HISTORIC AND DESIGN REVIEW COMMISSION

HDRC CASE NO: 2018-396
ADDRESS: 304 PIERCE
LEGAL DESCRIPTION: NCB 1275 BLK 7 LOT W 102 FT OF 8 & N 3 FT OF W 102.5 FT OF 9
ZONING: R-5, H
CITY COUNCIL DIST.: 2
DISTRICT: Government Hill Historic District
APPLICANT: Jorge Acosta
OWNER: Moises Cuevas
TYPE OF WORK: Construction of a two story, single family residential structure
APPLICATION RECEIVED: July 11, 2018
60-DAY REVIEW: September 9, 2018
REQUEST:

The applicant is requesting a Certificate of Appropriateness for approval to construct a two story, single family residential structure at 304 Pierce, located within the Government Hill Historic District.

**Historic and Design Review Commission
 Design Review Committee
 Report & Recommendation**

SITE PLAN
SCALE: 1"=20'-0"

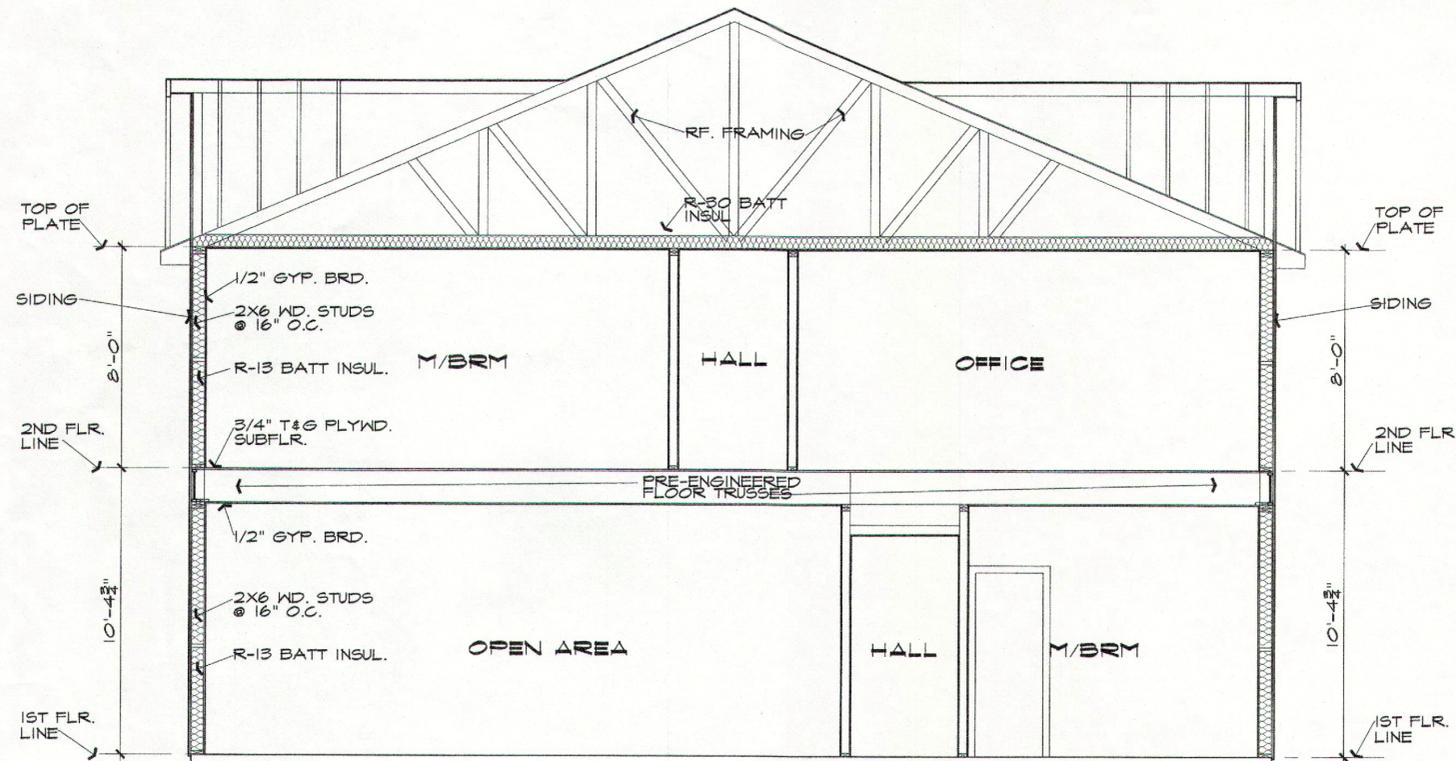
- b. DESIGN REVIEW COMMITTEE – This request was reviewed by the Design Review Committee on August 7, 2018. At that meeting committee members noted that the proposed footprint was inappropriate for the site, that setbacks should be greater than those of neighboring historic structures, that the proposed site plan should show neighboring properties and that the proposed parking was not appropriate.

- c. SETBACKS & ORIENTATION – According to the Guidelines for New Construction, the front facades of new buildings are to align with front facades of adjacent buildings where a consistent setback has been established along the street frontage. Additionally, the orientation of new construction should be consistent with the historic example found on the block. The applicant has proposed a setback of only ten (10) feet from the front property line. This is not consistent with the Guidelines. Staff finds that a setback that is greater than those found historically on the block should be used. Additionally, staff finds that the applicant should proposed side and rear setbacks that are comparable to those found historically in the district.

COMMENTS/CONCERNS: MG: PROPOSED FOOTPRINT IS CLOSE TO BEING
 A MAJORITY OF THE SITE. NO ESTABLISHED DRIVEWAY PATTERN ON

JE/CF: QUESTIONS REGARDING SETBACKS - SETBACKS SHOULD BE

GREATER THAN HISTORIC STRUCTURES ON BLOCK. MG: TWO STORY

MG: PARKING PAD IS NOT APPROPRIATE. CF: SITE PLAN SHOULD

SHOW ADJACENT BUILDINGS IN CONTEXT. CF: HOUSE SHOULD BE

- l. DRIVEWAY/FRONT YARD PARKING – Due to the proposed footprint of the new construction, the applicant a driveway in the side yard, comparable to those found historically in the district has not been proposed. As proposed, the front yard driveway presents an informal, front yard parking condition. This is not consistent with the Guidelines.
- m. LANDSCAPING – At this time, the applicant has not specified landscaping design. A landscaping plan should be included in an application for final approval.
